# Value Engineering

### Removal of Elwha and Glines Canyon Dams, Elwha River Ecosystem and Fisheries Restoration Project

April 25, 2003

Bureau of Reclamation, Technical Service Center, Denver, Colorado

Figure 8. Schedule, sheet 1 of 2

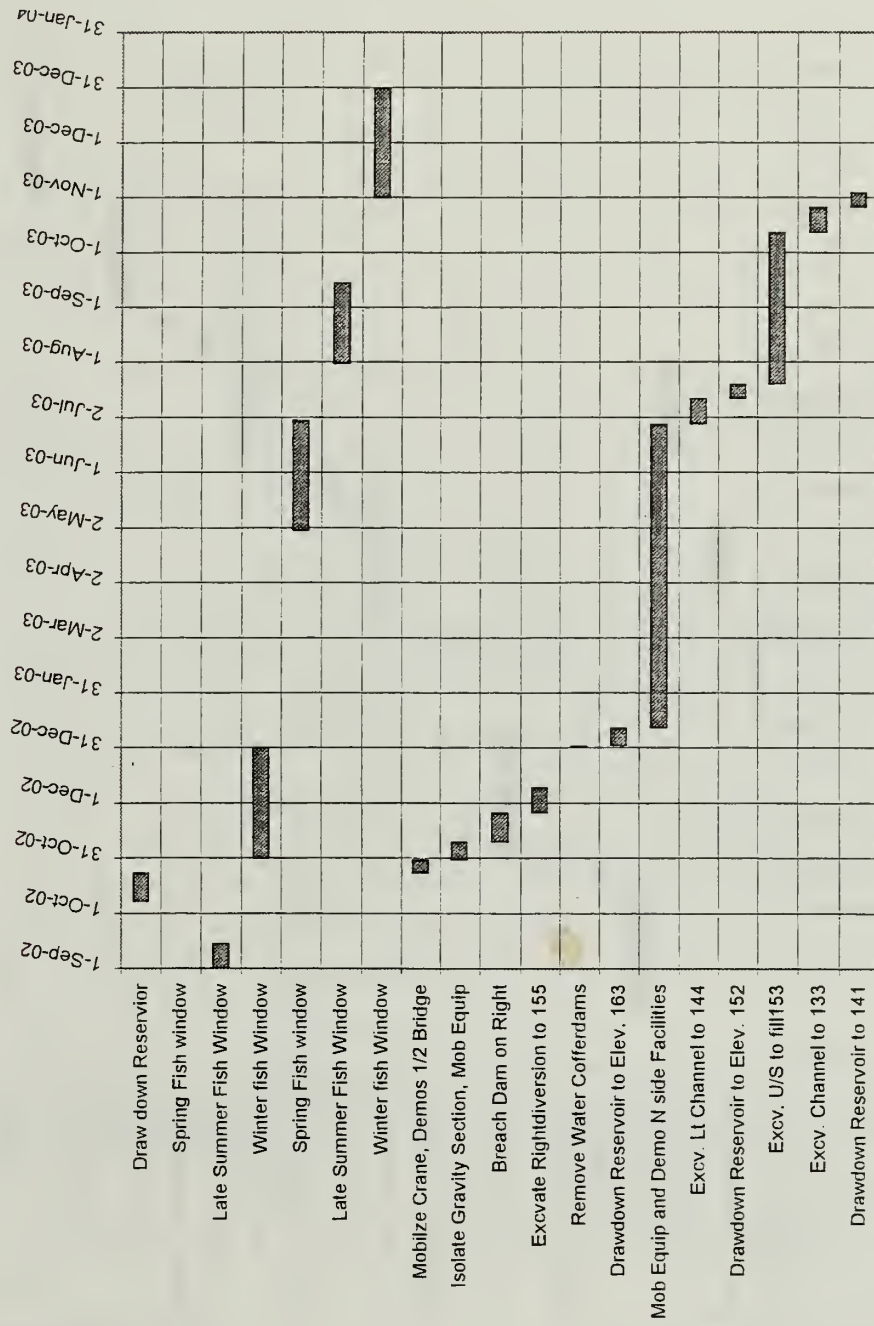
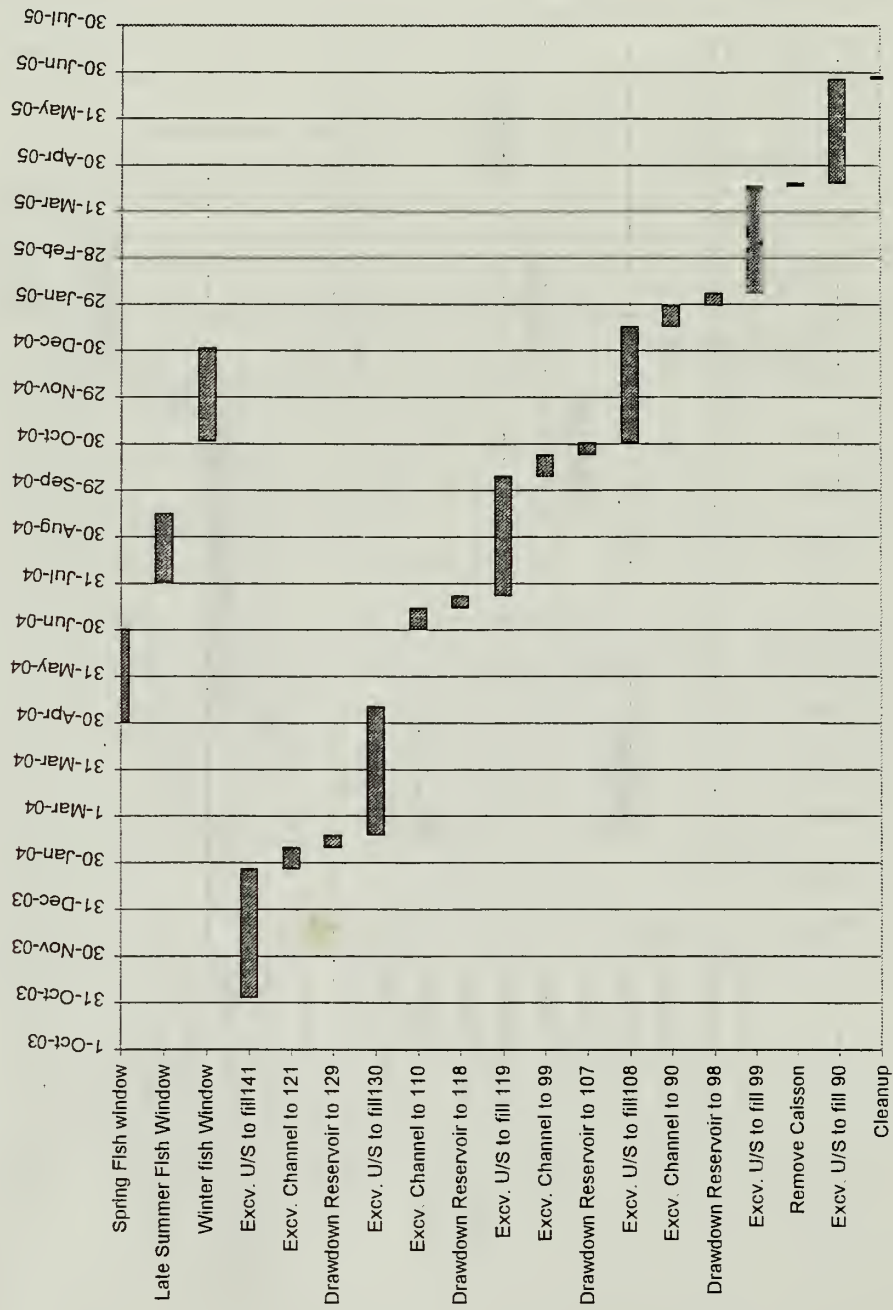
- Ways to Implement: See Figures 6 and 7 for schedule of implementation.
  1. Drawdown reservoir from El 197 to El 173+/- using Lt and Rt spillways and penstocks at a rate of 1 ½' per day limiting ramping to 1,000 cfs per hour. This is the same as the baseline but may be done following decommissioning of the power plant and before award of the contract.
  2. Mobilize crane to Rt spillway and demolish bridge/walkway over Rt spillway and Rt half of gravity dam.

# Figure 8. Right Diversion Channel

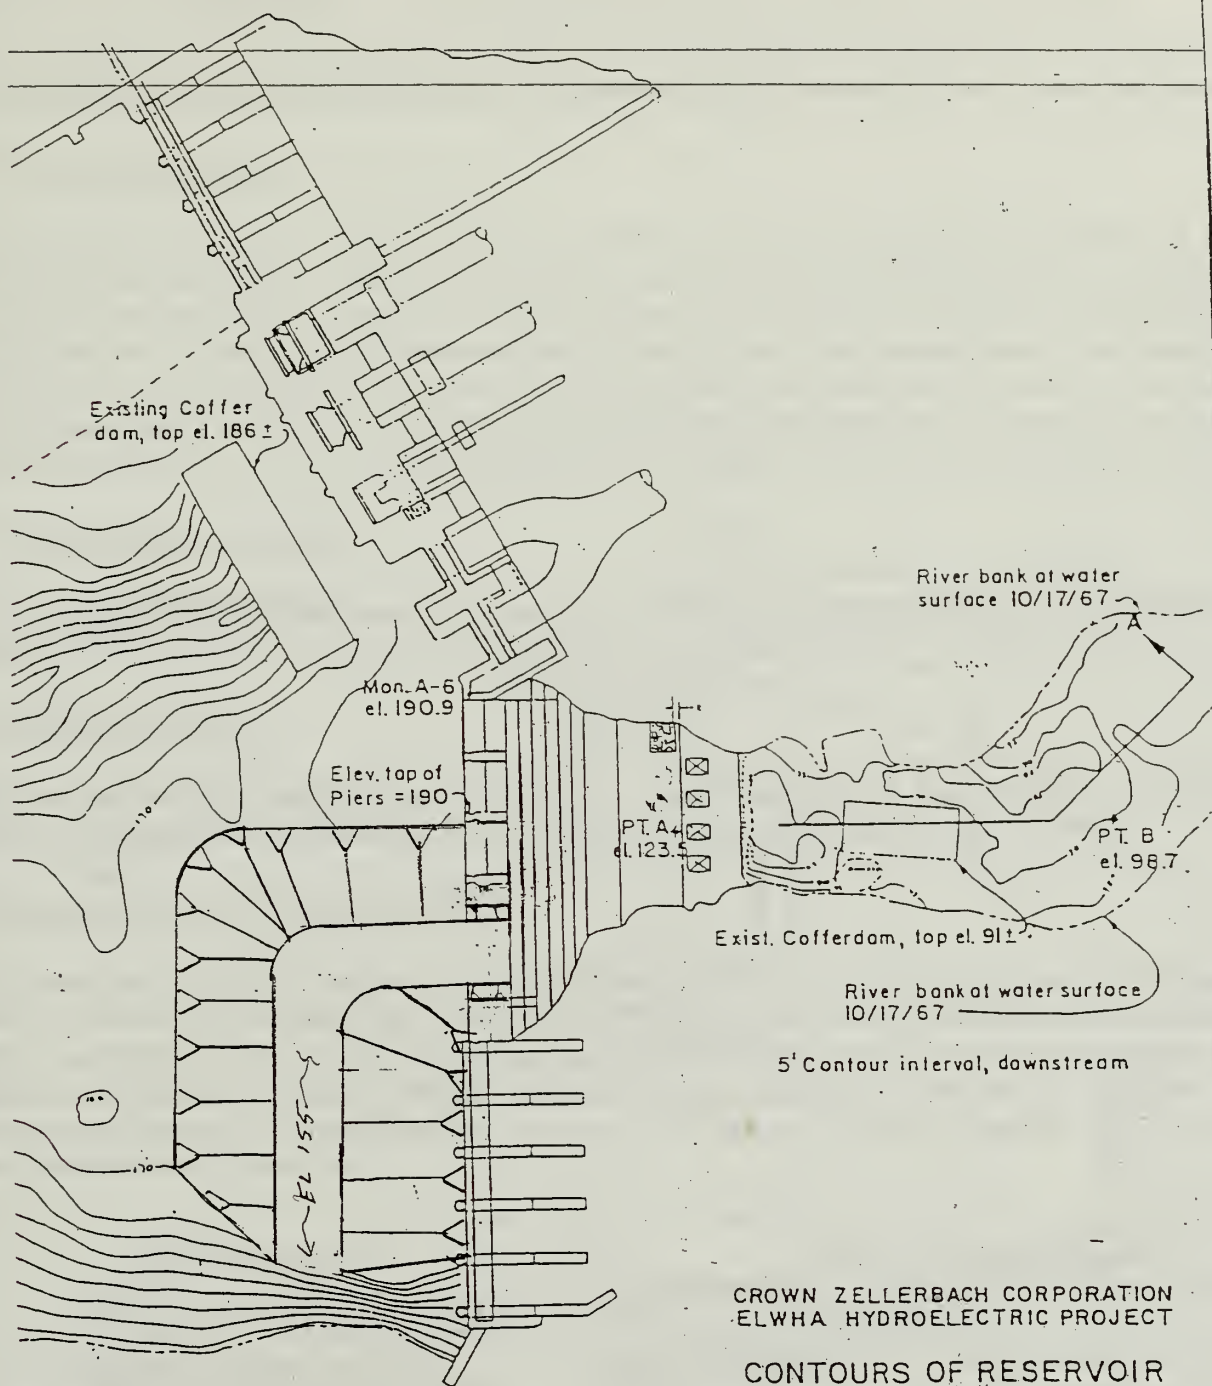
5. Demolish the right half of the dam and excavate adjacent upstream fill from El 194.5 to El 170.
6. Excavate diversion channel on Rt side through upstream fill and gravity section from El 170 to El 155 with bottom width of 20', side slopes of 2:1 through fill, and 1/4: 1 through dam. A plug will be left between the channel and reservoir. Figure 8 shows the completed diversion channel with out plugs.

Figure 9. Left Diversion Channel

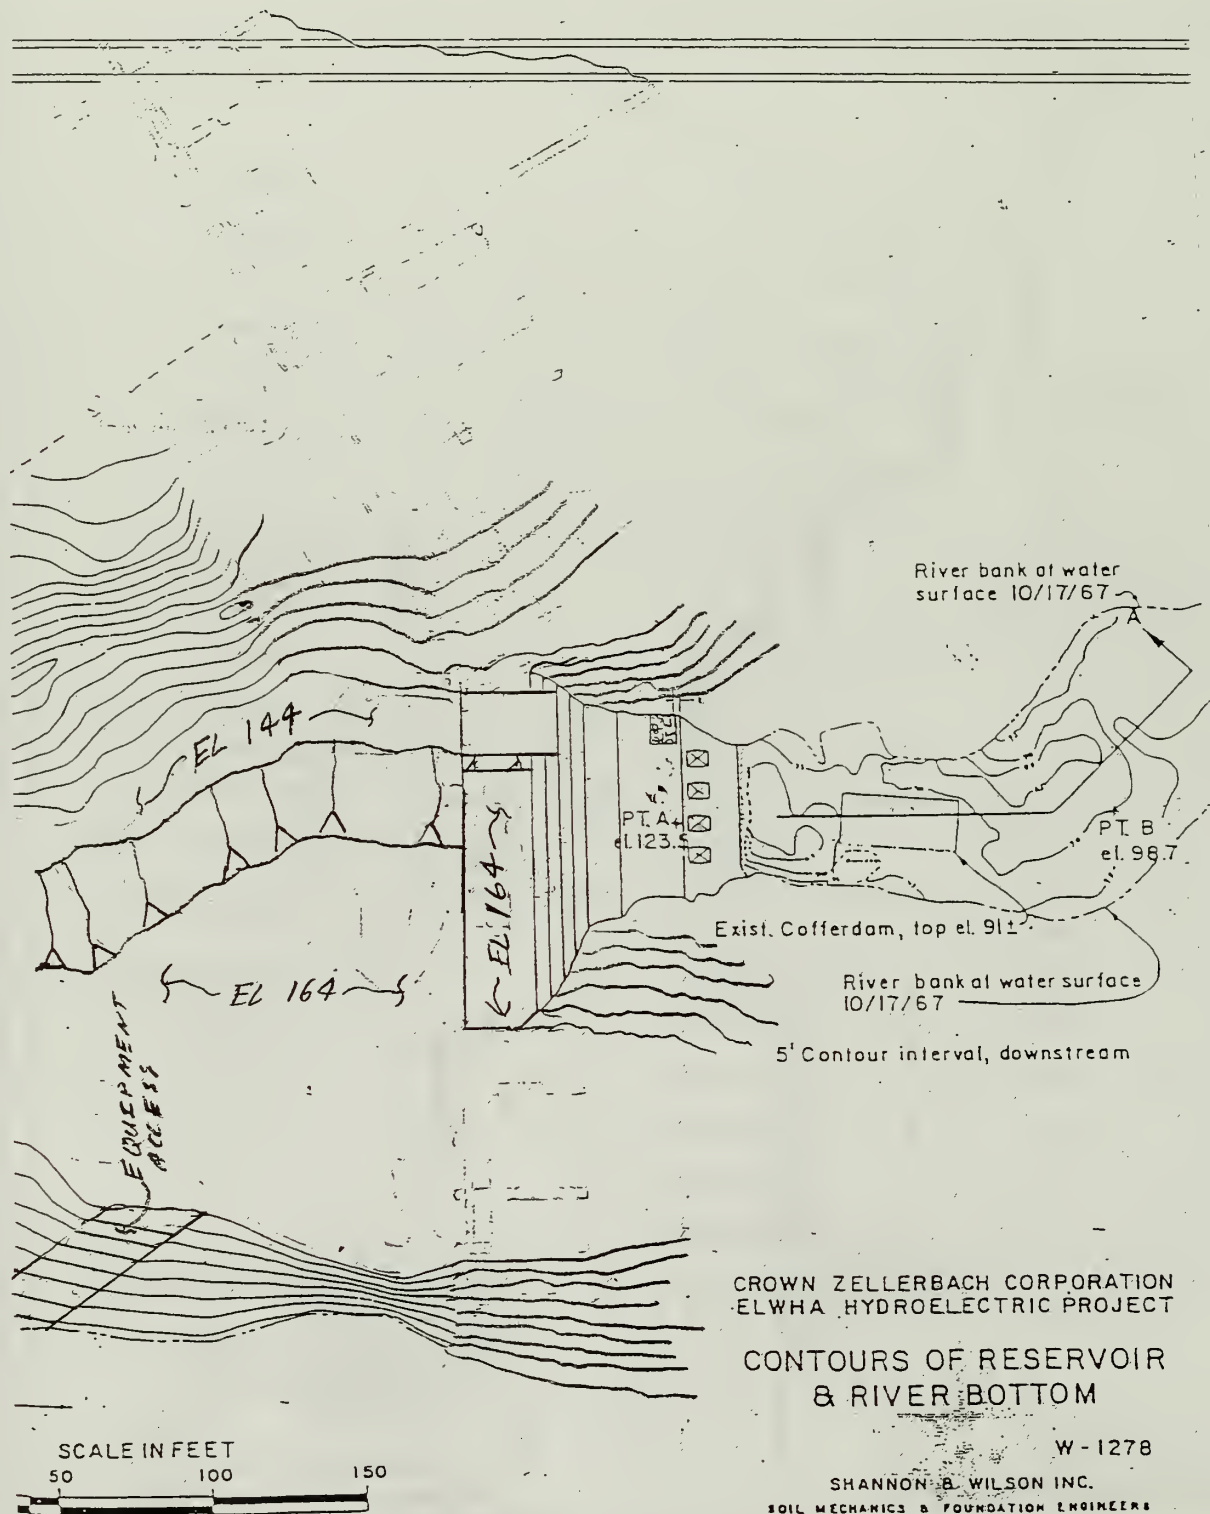
10. In conjunction with 8, and as equipment access requirements permit, excavate gravity dam from El 170 to El 164.
11. Excavate diversion channel on Lt abutment of the gravity dam through the upstream fill and the dam from El 164 to El 144. Leave plug between channel and reservoir and leave a section of the gravity dam crest in place from El 164 to 144. The concrete "plug" will prevent flows in the rock fill from moving to the left side prematurely. Figure 9 shows the completed diversion channel with out plugs.

Figure 10. Slope Contours, left side Elwha Dam.

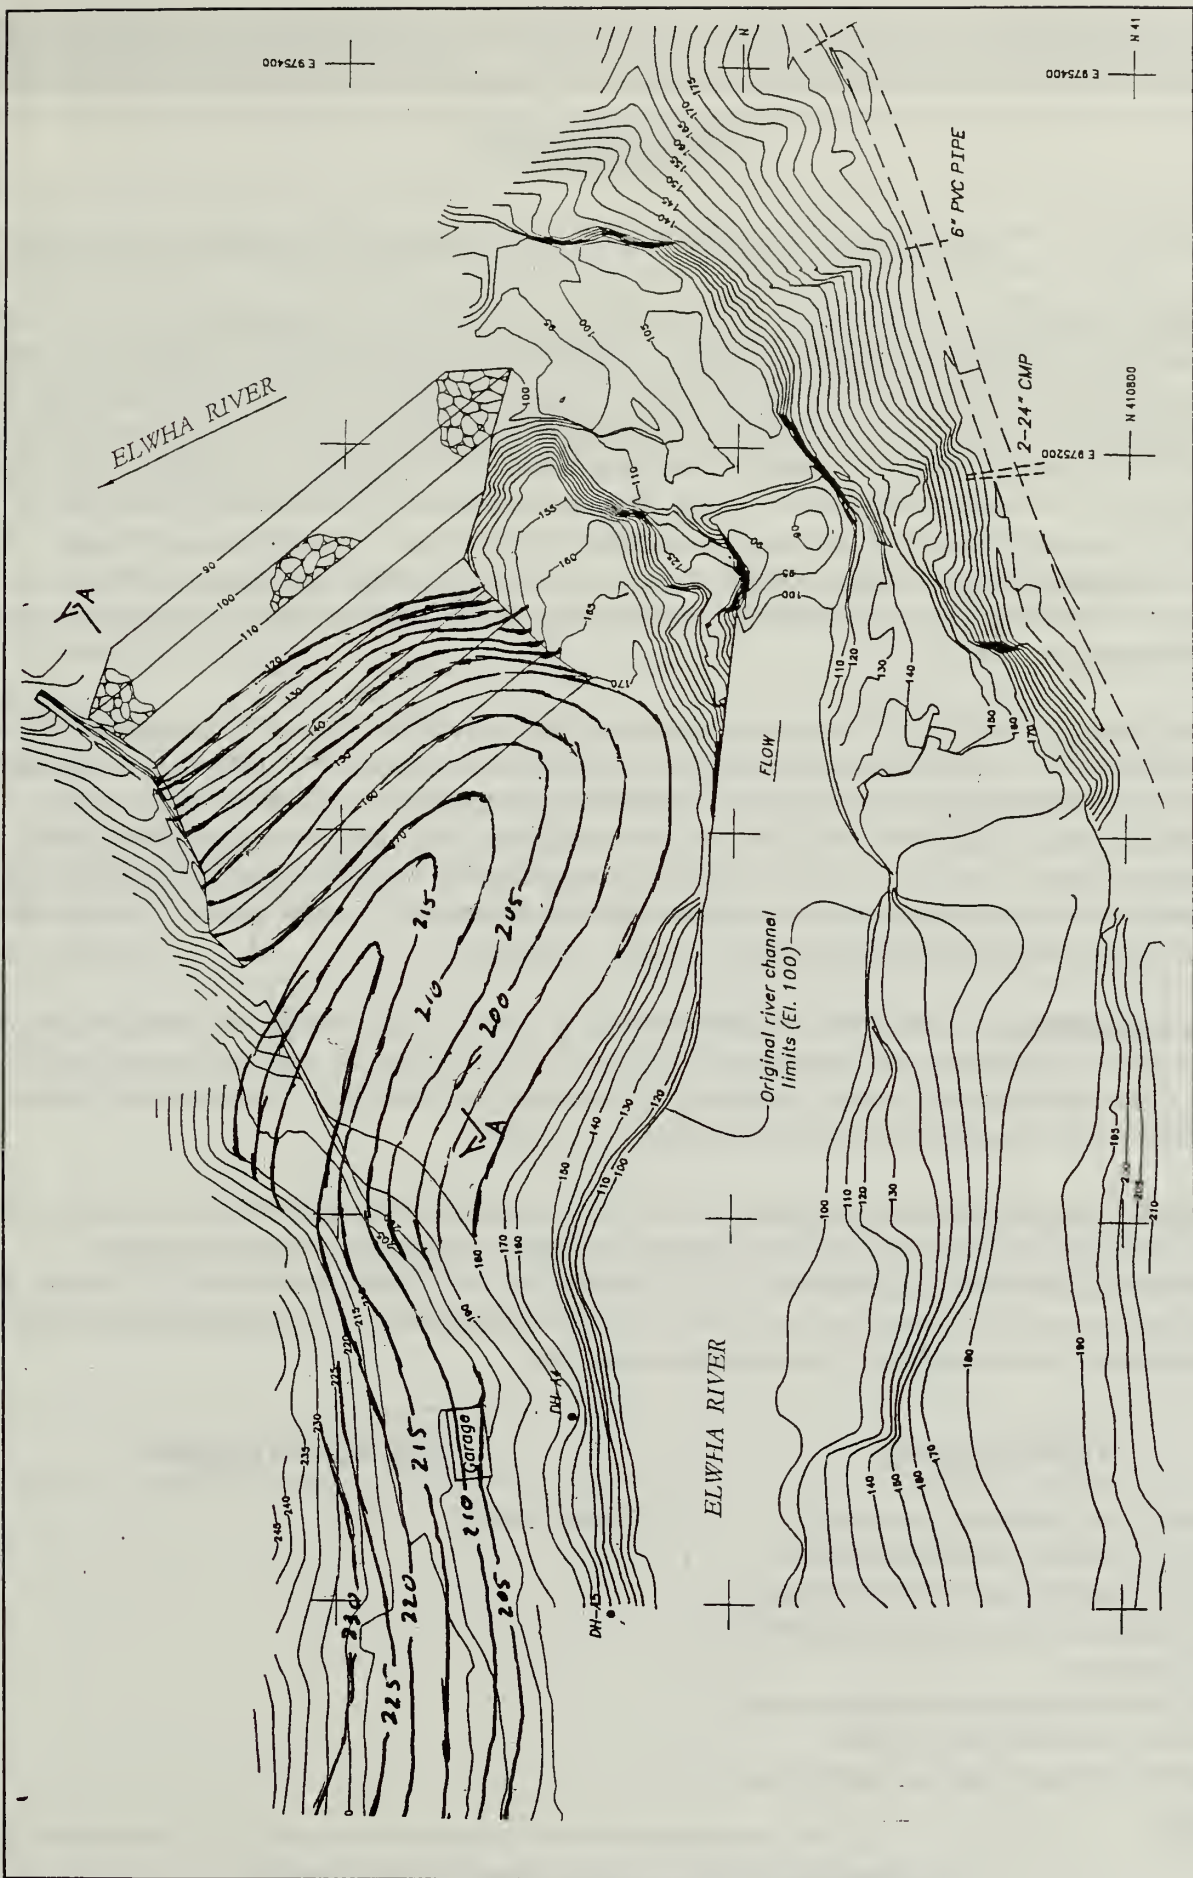
The proposal would be to create a “ridge” in the area of the left spillway and penstocks up to perhaps elevation 220+/- . See Figure 10. This would create a more natural looking topography and eliminate long distance hauling of approximately 50,000 cy of material. The proposal would leave portions of the left (north) spillway and intake in place and buried under the ridge of natural materials. The VE team feels that the uniformity of this area looks very un-natural, and feels that this area could be used as a waste area to dispose of lower spillway and intake structure concrete and cover with rock fill and other natural materials with minimum hauling required.

The Baseline Concept shows a large flat area at elevation 170 with a large uniformly sloped area down to the river at elevation 90. The VE Proposal is to use this area as a waste area to dispose of approximately 50,000 cy of material and at the same time create a more natural appearing hillside. Foundation portions of the spillway and intake structures would be left in place, eliminating the need for demolition and removal. The ridge of natural materials would be placed over the remaining concrete.
